Technical Service Bulletin 040407**HVPS Door Gasket**

This service bulletin affects all Comark IOX, Advantage, DCX, DCX Millennium, and DCX Paragon transmitters. The high voltage beam supplies provided with these transmitters feature a door gasket design that may be prone to failure in the field over time. This failure typically manifests itself as the infiltration of outside rain water into the air compartment of the beam supply. The result is a standing pool of water, which, if not addressed promptly, may lead to the failure of the fiberglass resistor support board, as previously addressed in Service Bulletin 030514 *HVPS Resistor Board*. An increased incidence of rust and other failures may also occur.

Snap on gasket

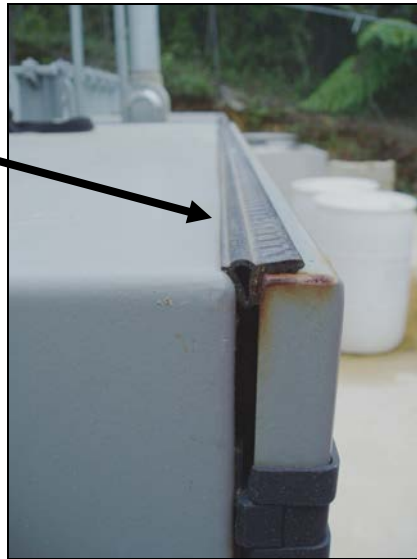
To eliminate this problem, Comark is offering a door gasket retrofit: P/N 609090-01 (contact Comark customer service for price and availability). The applicability of this retrofit to a particular beam supply may be determined by consulting the photograph below.

(essentially applies to all beams supplies produced after 1995)
